UNITED STATES PATENT AND TRADEMARK OFFICE

APPLICATION NO.	FILING DATE	FIRST NAMED INVENTOR	ATTORNEY DOCKET NO.	CONFIRMATION NO.
10/781,527	02/17/2004	Edward R. Katz	741501-1053	2433

Office Action Summary	Application No.	Applicant(s)	
	10/781,527	KATZ, EDWARD R.	
	Examiner	Art Unit	
	Mark R. Wendell	3609

DETAILED ACTION***Drawings***

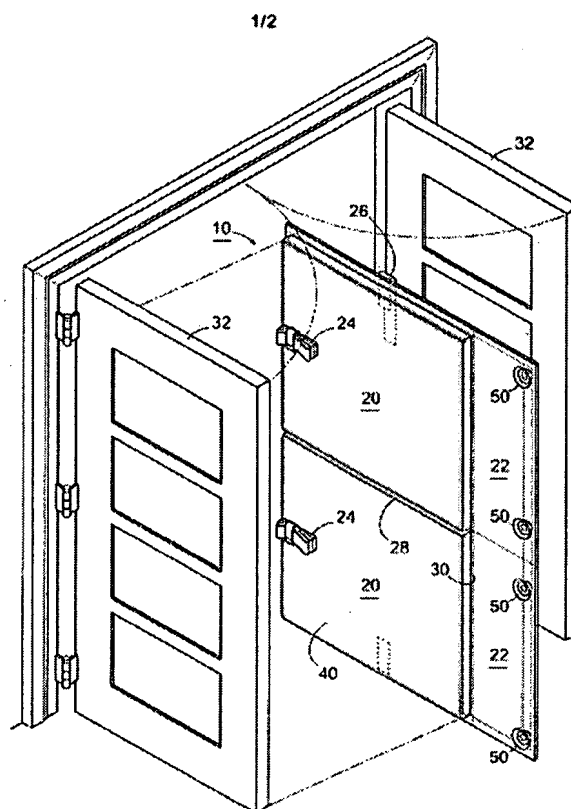
1. The drawings are objected to under 37 CFR 1.83(a). The drawings must show every feature of the invention specified in the claims. Therefore, the "plurality of ribs" discussed in claims 6 and 7, along with the main protective sleeve of claim 10 must be shown or the features canceled from the claims. No new matter should be entered.
2. The drawings are objected to because figures 1 and 3 are inconsistent with respect to the minor flap (22) as shown below.

Corrected drawing sheets in compliance with 37 CFR 1.121(d) are required in reply to the Office action to avoid abandonment of the application. Any amended replacement drawing sheet should include all of the figures appearing on the immediate prior version of the sheet, even if only one figure is being amended. The figure or figure number of an amended drawing should not be labeled as "amended." If a drawing figure is to be canceled, the appropriate figure must be removed from the replacement sheet, and where necessary, the remaining figures must be renumbered and appropriate changes made to the brief description of the several views of the drawings for
